**CITY OF AUSTIN
Board of Adjustment
Decision Sheet**

**CASE NUMBER: C15-2020-0003
Item # P-5**

ADDRESS: 3409 NEAL ST

3409 NEAL STREET
RESUBDIVISION OF EAST ONE-HALF OF LOT 3, BLOCK A,
CHERICO SUBDIVISION

3409 NEAL STREET
RESUBDIVISION OF EAST ONE-HALF OF LOT 3, BLOCK A,
CHERICO SUBDIVISION

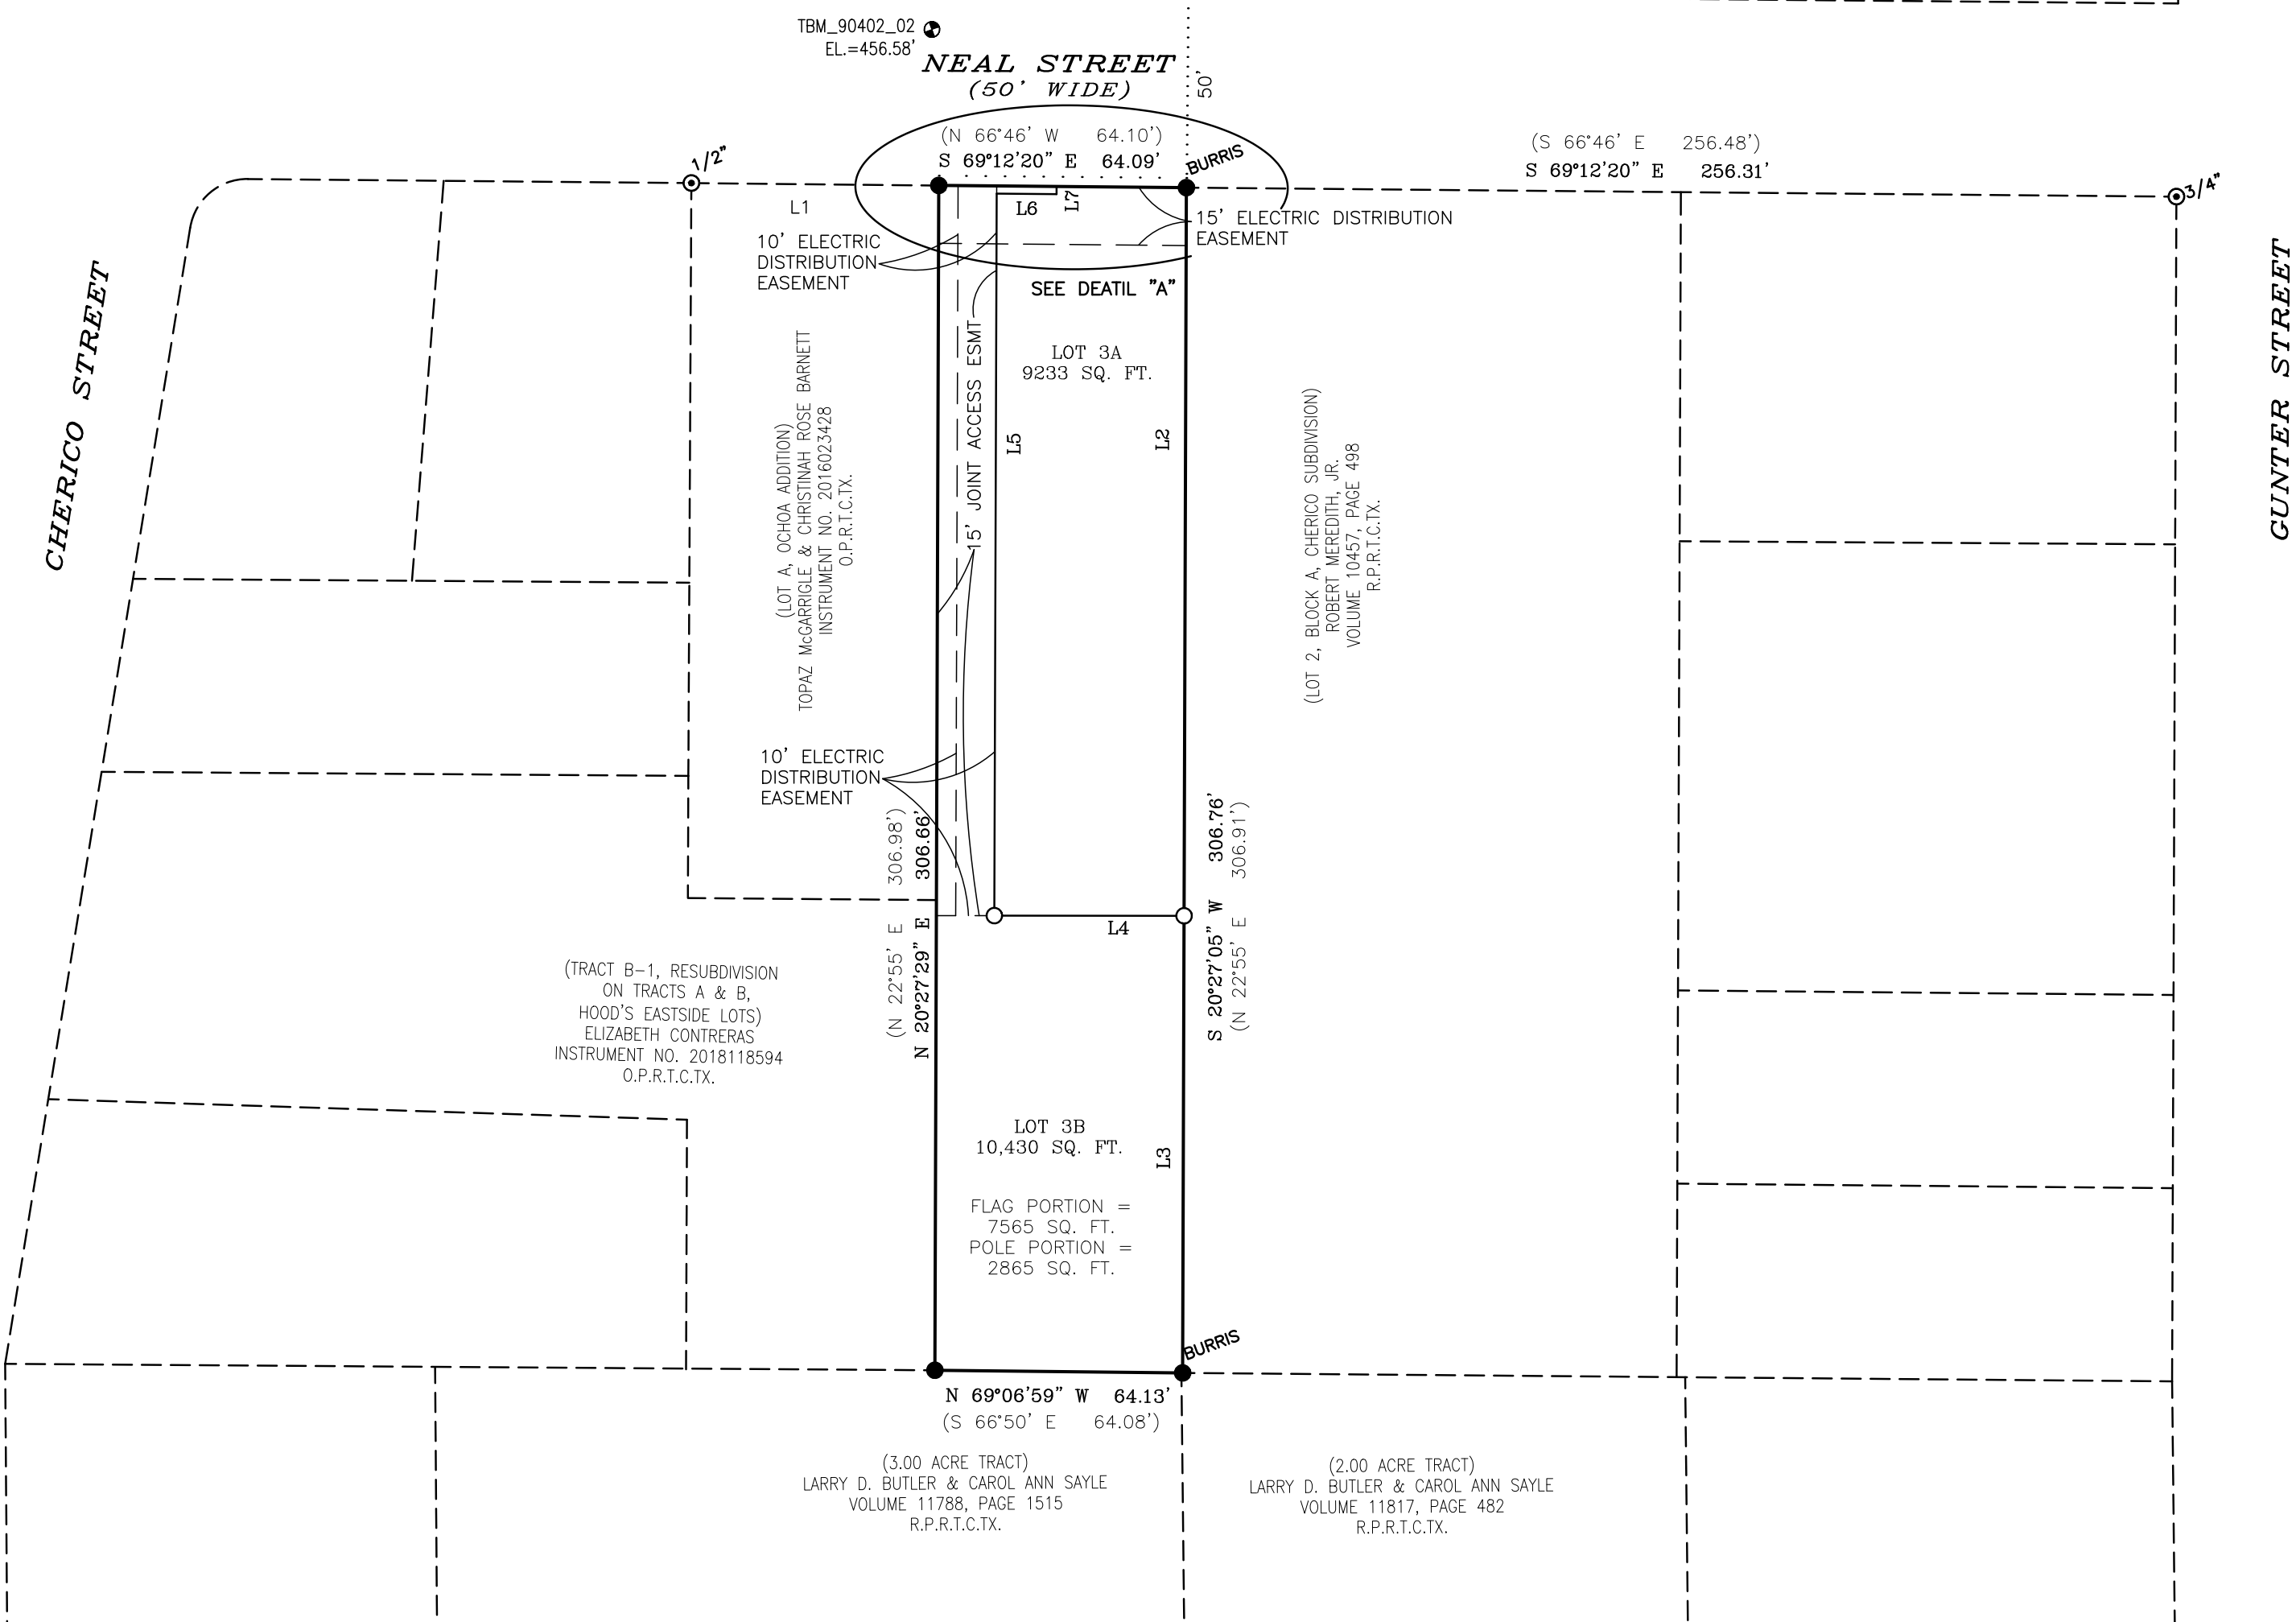
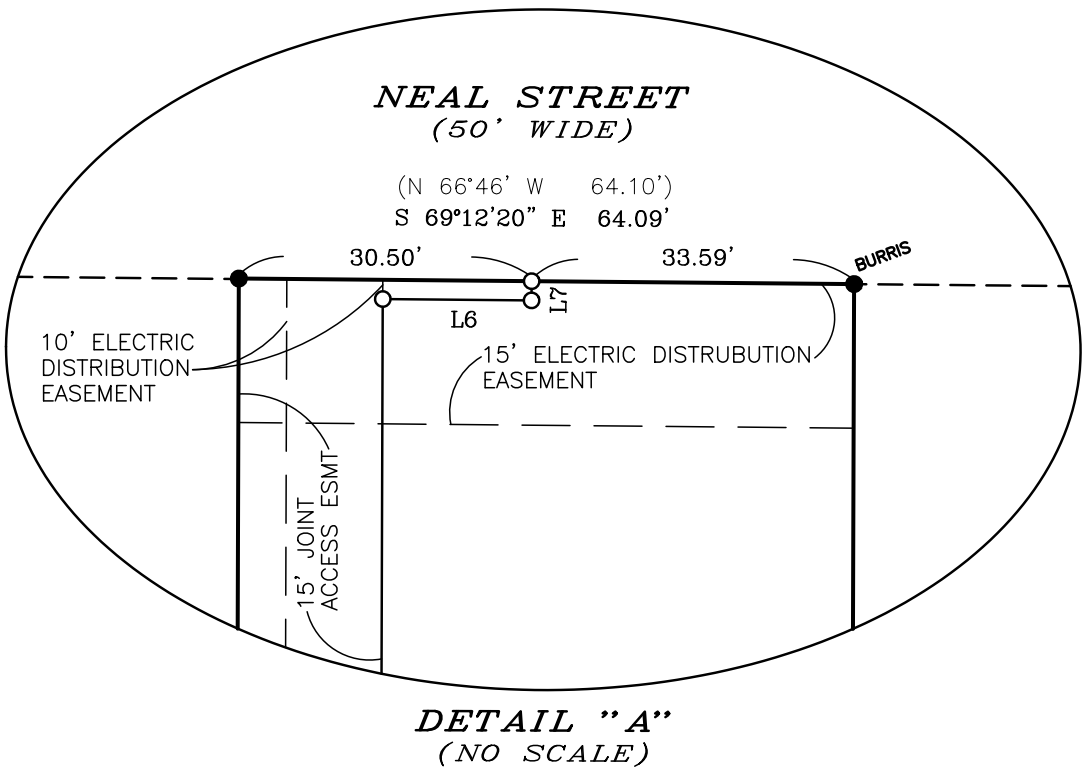
EL2. Provide a large sheet (24X36) of the driveway plan and profile plan. AW and AE do not share trenching. Provide utility assignments showing the electrical service to the back lot with a 10 ft. electrical easement and AW will need their own easement and provide AW's approval of separation from AE trenching. Plans are not readable.

UPDATE3: On a phone call the applicant was to verify their disconnect will be along the ROW for the flag lot with their MEP. Electrical Easement within the development is shown for the flag lot and private W/WW are shown within it. Not allowed.

PERMIT PARTNERS/AERPARMIA RESPONSE: SEE ATTACHED REVISED PLAT AND UTILITY PLAN. PLEASE EMAIL EITHER MIA OR I DIRECT IF THERE ARE STILL CHANGES NEEDED ON THIS PLAN – MPARTON@AEPARMIA.COM OR JENNIFER@PERMIT-PARTNERS.COM

REASONING BEHIND ADDING THIS EASEMENT & IN ORDER TO CLEAR EL2 COMMENT:

Per Bowman - according to her images, Karen thought the private w/ww lines were in the AE easement because of how the plat was drawn up. Editing it to show the 5' gap between the fence and the easement shows the lines are fine.
